Marvell[®] PXA270M Processor

Specification Update

Doc. No. MV-S900957-00 Rev. I, PUBLIC RELEASE
April 19, 2010

Figure 6-33. Quick Capture Interface Timing

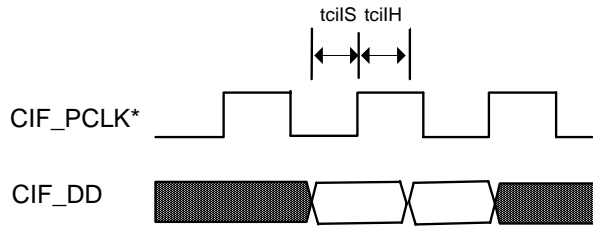
S12. Quick Capture Interface AC Timing Added

Section 6.8 Quick Capture Interface AC Timing should be added to the PXA270 Processor Family Electrical, Mechanical, and Thermal Specification and the PXA27x Processor Family Electrical, Mechanical, and Thermal Specification.

Table 6-27 lists the timing parameters used in Figure 6-33.

Symbol	Description	Min	Typical	Max	Units
tcilS	Camera Interface Setup Time	5	—	—	ns
tcilH	Camera Interface Hold Time	5	—	—	ns

Figure 6-28. LCD Timing Definitions

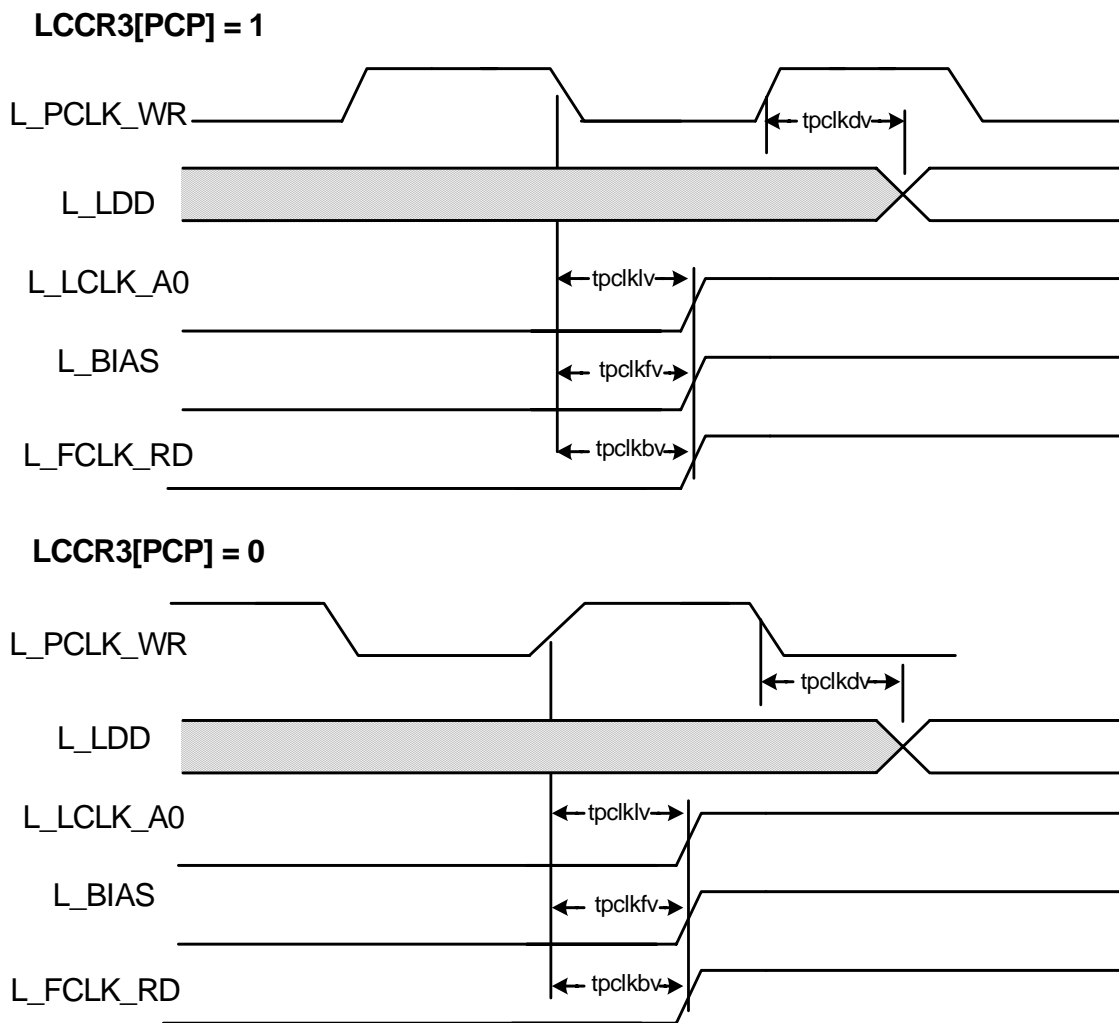
In Table 6-22 LCD Timing Specifications of the PXA270 Processor Family Electrical, Mechanical, and Thermal Specification and PXA27x Processor Family Electrical, Mechanical, and Thermal Specification, the maximum values of Tpclkv, Tpclkv and Tpclkv should be updated. The associated Figure 6-28 LCD Timing Definitions should be updated to correct the timing relations relative to the LCCR3[PCP] setting.

Figure 6-28 should be replaced with:

Symbol	Description	Min	Max	Units	Notes
Tpclkdv	L_PCLK_WR rise/fall to L_LDD<17:0> driven valid	—	7	ns	1
Tpclkiv	L_PCLK_WR fall to L_LCLK_A0 driven valid	—	7	ns	2
Tpclkfv	L_PCLK_WR fall to L_FCLK_RD driven valid	—	7	ns	2
Tpclkbv	L_PCLK_WR rise to L_BIAS driven valid	—	14	ns	2

Figure 6-33. MultiMedia Card timing Diagrams

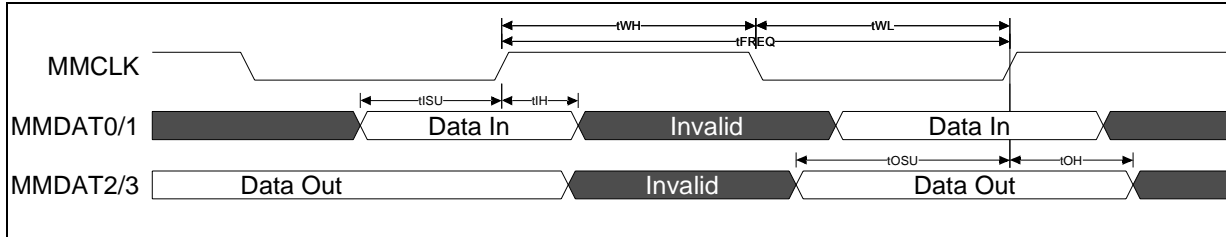
D36. MMC/SD/SDIO AC Timings Added

In Section 6 AC Timing Specifications, the following two subsections about MMC/SD/SDIO AC timings are now added.

Symbol	Parameter	Min	Max	Unit	Notes
t_{FREQ}	MMCLK Frequency Data Transfer Mode	0	19.5	MHz	
t_{FREQ}	MMCLK Frequency Identification Mode	0	400	KHz	
t_{WH}	Clock high time	10	—	ns	
t_{WL}	Clock low time	10	—	ns	
t_{rise}	Clock rise time	—	10	ns	1
t_{fall}	Clock fall time	—	10	ns	1
t_{ISU}	Data input setup time	3	—	ns	
t_{IH}	Data input hold time	3	—	ns	
t_{OSU}	Output data setup time	13.1	—	ns	
t_{OH}	Output data hold time	9.7	—	ns	
NOTE:					
1. Rise and fall times measured from 10% - 90% of voltage level.					
t_{WH}	Clock high time	10	—	ns	
t_{WL}	Clock low time	10	—	ns	
t_{rise}	Clock rise time	—	10	ns	1
t_{fall}	Clock fall time	—	10	ns	1

Figure 6-34. SD/SDIO timing diagrams

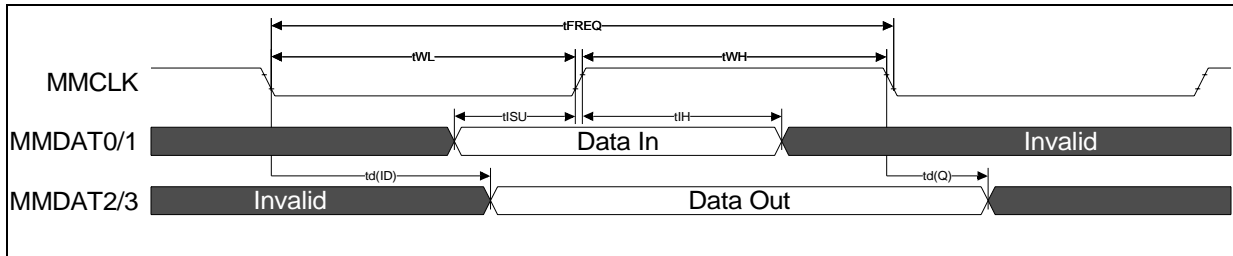
Figure 6-34 and Table 6-28 define the Secure Digital (SD/SDIO) controller AC timing specifications.

Symbol	Parameter	Min	Max	Unit	Notes
t_{FREQ}	MMCLK Frequency Data Transfer Mode	0	19.5	MHz	
t_{FREQ}	MMCLK Frequency Identification Mode	0 ¹ /100	400	KHz	
t_{WH}	Clock high time	50	—	ns	
t_{WL}	Clock low time	50	—	ns	
t_{rise}	Clock rise time	—	10	ns	2
t_{fall}	Clock fall time	—	10	ns	2
t_{ISU}	Data input setup time	5	—	ns	
t_{IH}	Data input hold time	5	—	ns	
$t_{d(Q)}$	Output Delay time during Data Transfer Mode	0	14	ns	
$t_{d(ID)}$	Output Delay time during Identification Mode	0	50	ns
